## SERVICE CAMPAIGN BULLETIN

**TITLE:** Hood Latch Replacement - ROW

**DOCUMENT NUMBER:** 12 A 007

**AFFECTED VEHICLES:** McLaren P1™

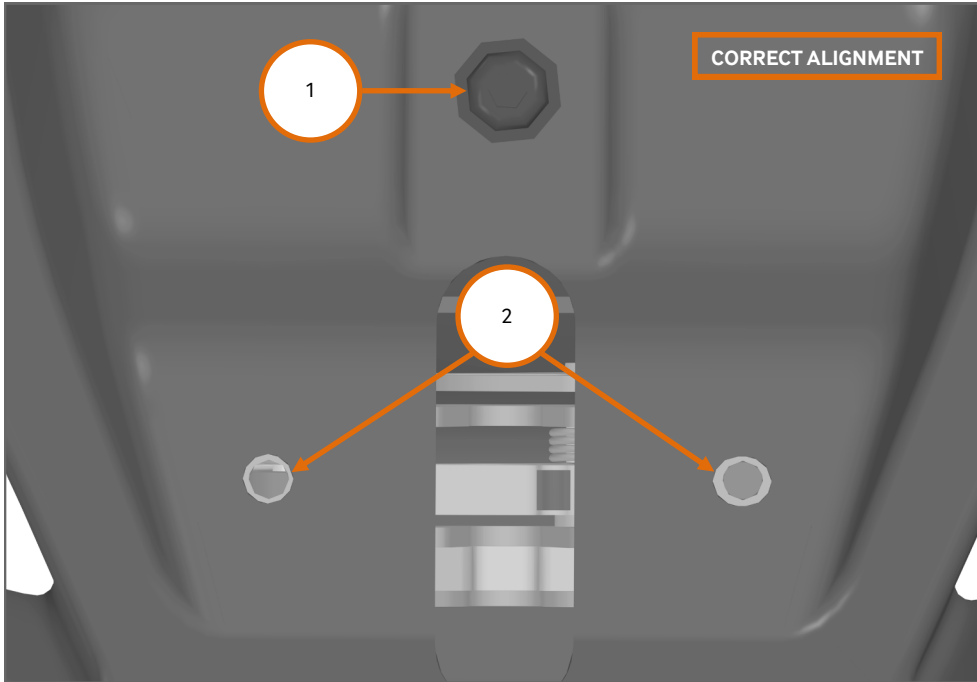
**SITUATION:** Due to a tolerance build-up of the internal components within the McLaren P1™ hood latch, there is a chance that when the secondary latch becomes disengaged (by pressing the button found in the hood) and is then re-engaged, the solenoid plunger in the secondary latch may miss the latch hole, causing the secondary latch to remain disengaged.

If this occurs, the secondary latch will not function properly and may not retain the hood and the hood may open whilst the vehicle is moving.

**PROCEDURE:** Please follow the instructions outlined in this document to replace the hood latch.

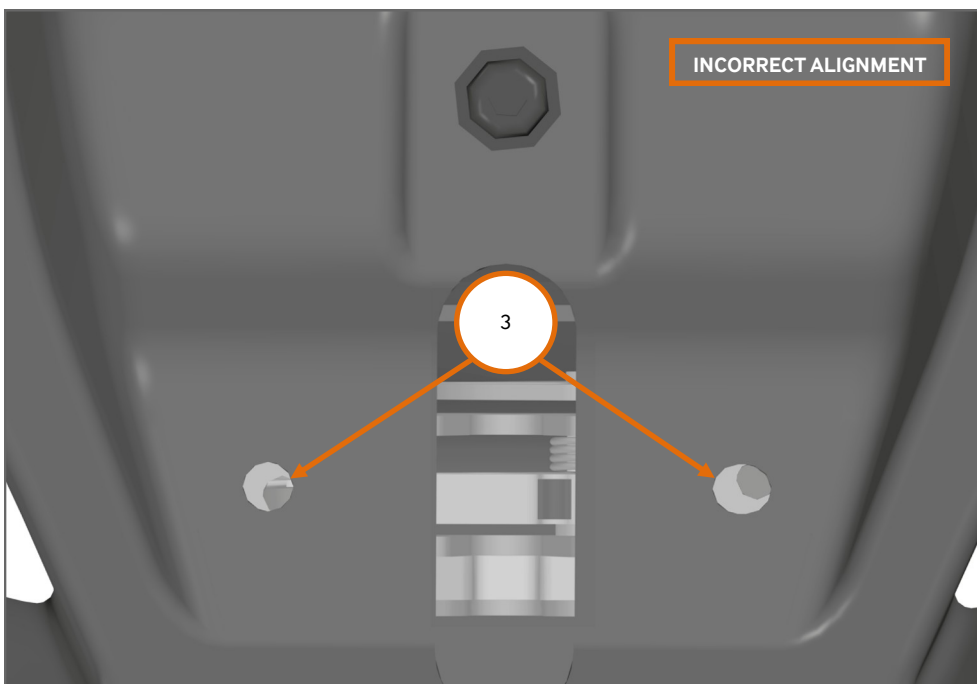
1. Please refer to BA-RM-02A052-03-001 Remove/install latch - Luggage compartment lid, to remove the hood latch.
2. Check for correct alignment of the new hood latch by fitting the top fixing bolt (1) and checking if the lower fixing points (2) of the latch are fully aligned with the holes in the front clam.
3. If the lower fixing holes (2) of the latch fully align with the clam fixing holes then proceed and install the new hood latch. Please refer to Step 8.

4. If the fixing holes of the latch are **not** fully aligned (3) with the clam fixing holes please refer to Step 5.

**Care Point:** Do not attempt to install the remaining two fixing bolts if the lower fixing holes are not aligned.

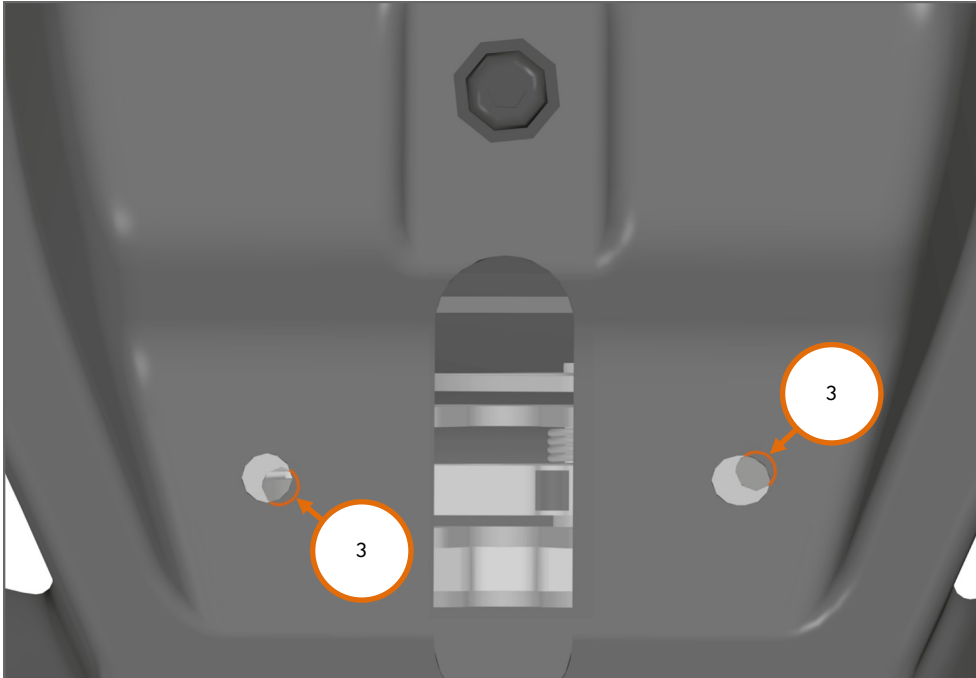
5. Mark up with a marker pen the area around the lower clam fixing holes where carbon material needs to be removed (3) to ensure that the fixing holes of the latch and the fixing holes of the clam are fully aligned.

**Care Point:** Do not remove more than 3mm of material from any of the clam fixing holes.

**Care Point:** Remove an equal amount of material from each clam fixing hole in order to keep the latch centralised.

**Care Point:** Do not remove any material from the threaded latch fixing holes.

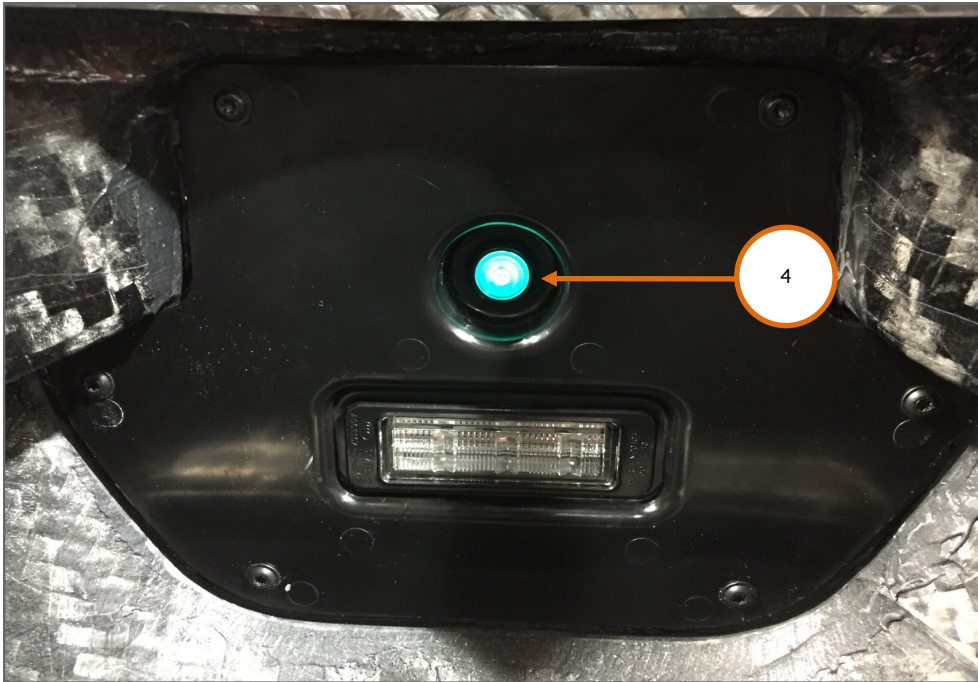
7. Using a needle file, remove material in the areas marked with paint at step 5.

**Care Point:** Use a vacuum cleaner to remove fillings whilst reworking.
